This form has been developed to document changes to the NorthMet Project and/or Project SDEIS Water Modeling resulting from the water modeling process. The forms will be used during the water modeling process. At the end of the process, the Project Description, Data Packages and Management Plans will all be updated to reflect the content of all forms submitted during the process.

Model Refinement

Figure 1 Conceptual drawing of the modeled groundwater flow paths at the Plant Site

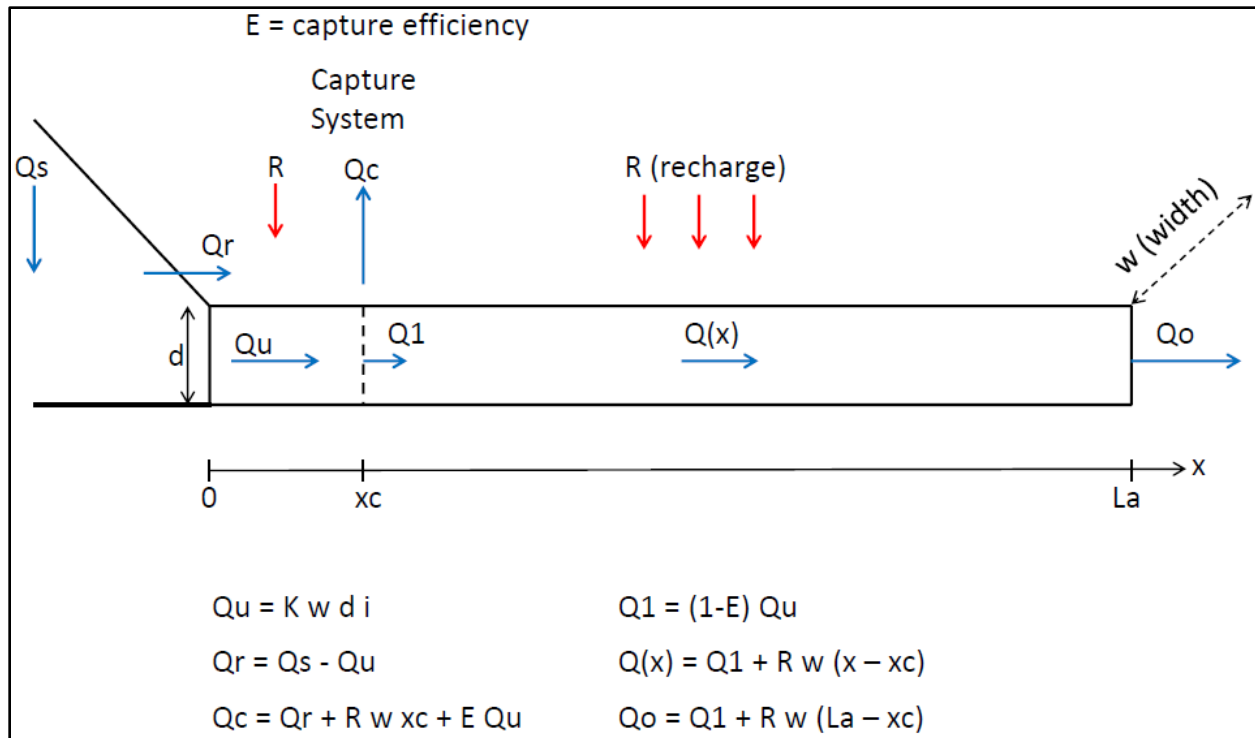
In Figure 1, Q_s is the total seepage rate from the Tailings Basin to the toe (as calculated in the GoldSim model as a function of percolation rates through the tailings), Q_u is the flow that enters the aquifer, Q_r is the flow that is in excess of the aquifer capacity and upwells to surface flow, Q_1 is the flow that bypasses the containment system, Q_c is the flow that is captured by the containment system, and Q_o is the flow discharging from the flow path to surface water.

The proposed change in this CDF applies to both the existing conditions or No Action model and the Proposed Project model. In both models, the upstream flow (Q_u) will be calculated in the same manner and flow and mass load from recharge will be added to every cell of the flow path. However, in the Proposed Project model, a collection system will be installed a short distance (~250 feet) from the toe of the Tailings Basin. The collection system described in the Adaptive Water Management Plan (AWMP, see Section 7.4.3 of Reference 2) is designed to capture all surface and groundwater flow. However, for the modeling, it is assumed that the collection system will capture 100% of the surface flow (Q_s in excess of Q_u , or Q_r) and 90% of the flow at the upstream end of the aquifer (Q_u). Therefore, the groundwater flow that bypasses the collection system (Q_1) will be 10% of Q_u (see Equation 3). In the Proposed Project model, flow and mass load from recharge will continue to be added to flow path along the remaining length beyond the collection system until the discharge location.

$$Q_1 = (1 - 0.9) * Q_u \tag{Equation 3}$$
